Access Compliance Report

Public Rights-of-Way

| Intersection ID: 45310 | Main Street: BENFIELD_RD | Cross Street: RIDGE_RD | Location: NE |
| ADA ID: E53028D2CFD4 | Ramp Type: Perp | Initial Pass/Fail: Fail | Overall Compliance: No |

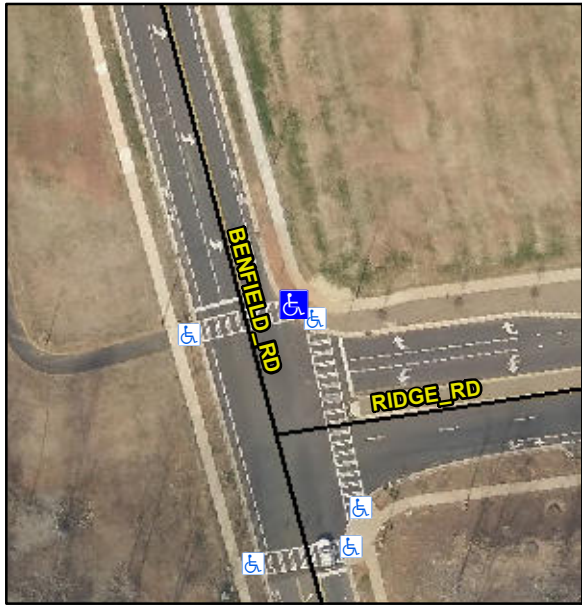
| Codes/Mitigation Info/Possible Solution | | | Field Measurements/Component Compliance | | | | | |
|--|--|-----|---|-----------------------|-------------|-----------------------------|-----------------------|-------------|
| | Remove & Replace Entire Ramp. | | N/A | Ramp Length (in) | 66.0 | No | Ramp Slope (%) | 10.4 |
| <p>Surveyor Notes:</p> <p>N/A</p> <p>PROW/ADA:</p> <p>R304.2.2</p> | | | N/A | Landing Curb? (Y/N) | N/A | N/A | DWS Offset (in) | N/A |
